Design Review Subcommittee (DRSC)

Meeting Date: July 25, 2018

SUBJECT: **Conditional Use Permit 17-322 and Minor Cultural Heritage Permit 17-420, La Colombiana Expansion,** a request to consider 1) expansion of the existing restaurant use to include full alcohol service indoors and outdoors, 2) an expansion of the outdoor dining area, and 3) minor exterior modifications.

Project: CUP 17-322 & MCHP 17-420

Figure 2: Proposed Front Building Façade
(El Camino Frontage)

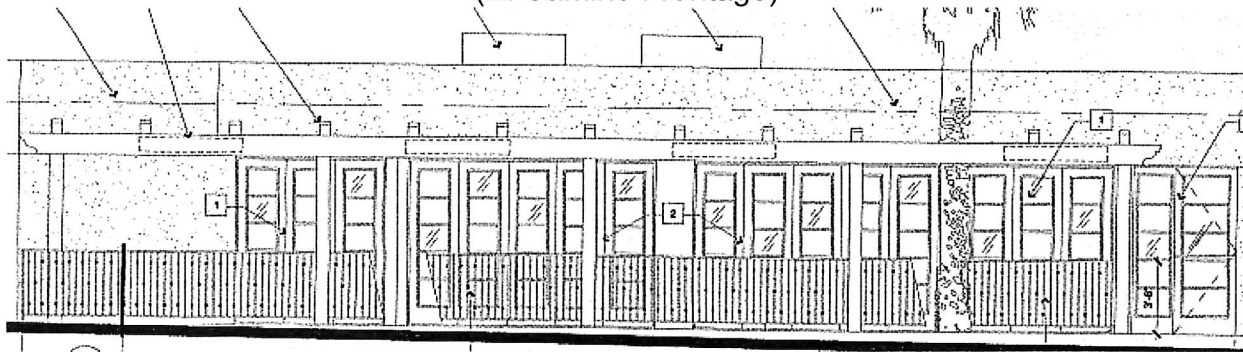
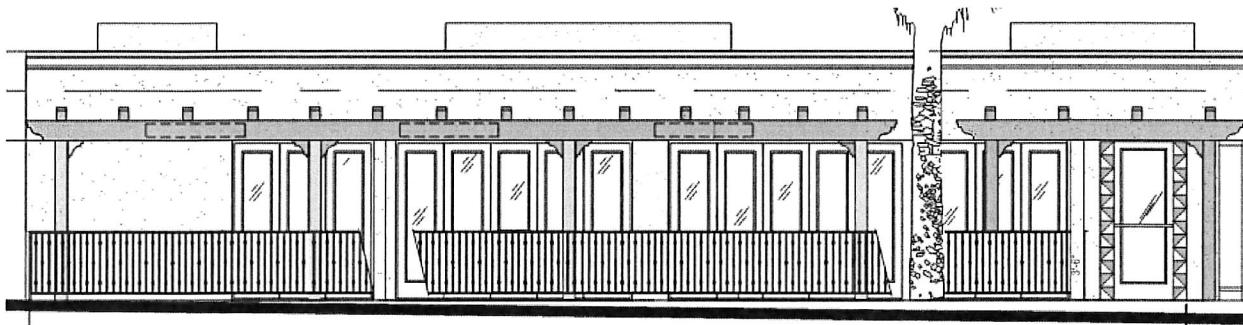
DRSC Recommendation	Applicant Response
1. Provide more façade improvements that bring the structure closer to Spanish Colonial Revival style.	Partially addressed. The applicant addressed specific DRSC comments, which are detailed below. Some of the general changes made to the structure are partial in nature, as the applicant states there are budget constraints that make a full front and rear façade remodel infeasible at this time-please see Attachment 4.

3. Remove the eyebrow façade element from the building.	Partially addressed. The applicant removed the eyebrow element from the front façade only. The applicant states that due to budget constraints, the existing eyebrow will remain on the rear (alley-facing) façade.

DRSC Recommendation	Applicant Response
4. Provide a detail element around the top of building, where the roofline and block wall meet.	Addressed. A cornice detail is proposed on the front elevation of the building. The applicant states that due to budget constraints, the cornice detail is not proposed around the entirety of the building.

While the proposed modifications incorporate some Spanish Colonial Revival elements and style, the applicant ultimately proposes a partial façade improvement of the building. A majority of the changes proposed are to the front façade, with little improvement proposed to the rear and sides of the building, all of which are visible either from El Camino Real or from the back alley. The City Design Guidelines states that “all building elevations will be evaluated in City reviews,” and it encourages the “rear and side façade to be compatible with the principle facades of the building.” Staff would prefer to see the proposed modifications incorporate comprehensive changes to the aspects of the building that are inconsistent with Spanish Colonial Revival style, such as full removal of the eyebrow element, and the application of smooth white stucco to the entire building.

- 1.) Dimensions have been added to the floor plan, refer to sheet A2.0.
2.) Eyebrow roof has been removed from the front elevation, refer to exterior elevations sheet A3.0. Due to budget constraints, the eyebrow will remain at the rear of the building.

3.) In keeping with the Spanish Colonial Revival design, a proposed cornice detail at the Front Elevation of the building has been added. Due to budget constraints, the cornice will not be installed at the entire perimeter of the building.

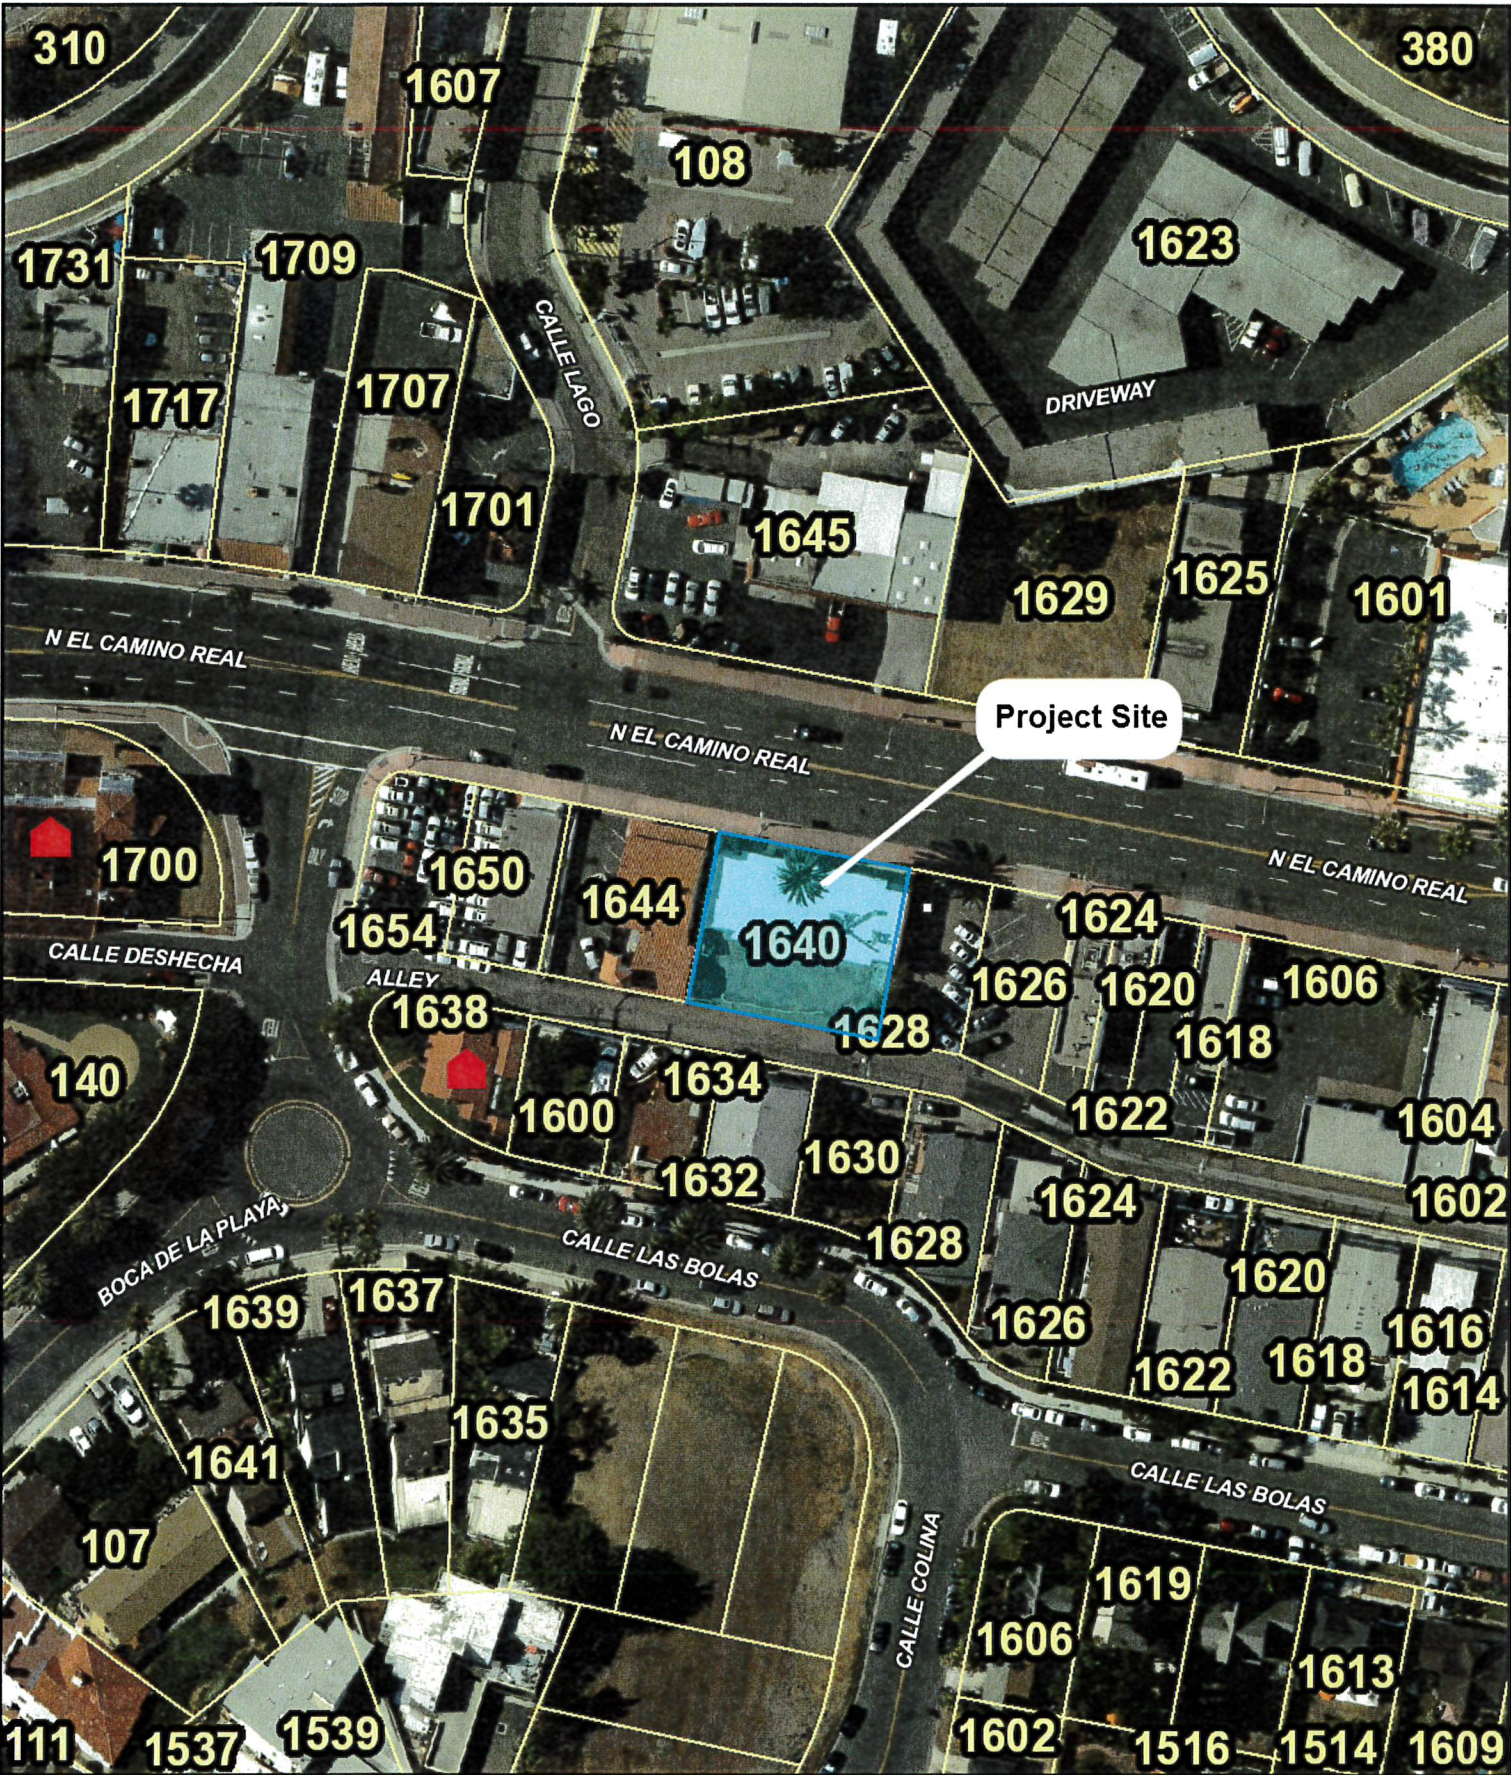
To improve the project's consistency with the City Design Guidelines, which include requiring façade improvements to be consistently applied to all building elevations, staff recommends the following project modifications:

- The full removal of the eyebrow element would drastically improve the aesthetic of the building, and remove an element that detracts from SCR style. Additionally, the entire building should be painted to be consistent in color palette and finish. Staff is considering conditions of approval to remove the eyebrow from the building fully, however, the applicant stated they do not want to remove the entire eyebrow element due to cost and due to the property owner's hesitancy to remove the eyebrow element. For reference, other project specific conditions of approval could entail restriping of the parking lot area and a consistent painting of the entire building.

- Staff also recommends the applicant provide elevations of the proposed trash enclosure, detailing materials, color, and dimensions. The trash enclosure should be improved consistent with the required SCR style, and be complimentary to the primary building in materials and color. Since the trash enclosure is visible from the alley, the addition of landscaping to the trash enclosure walls is preferable. The applicant seeks to refrain from the use of wall vines on the rear of the structure and primary building, as he feels it could create a habitat for rodents. Typically, climbing vines are encouraged for trash enclosures, however staff recommends medium height plants to accommodate the applicant's concerns, such as Podocarpus Maki, Kangaroo Paw, or Feather Reed Grass (see Attachment 8).
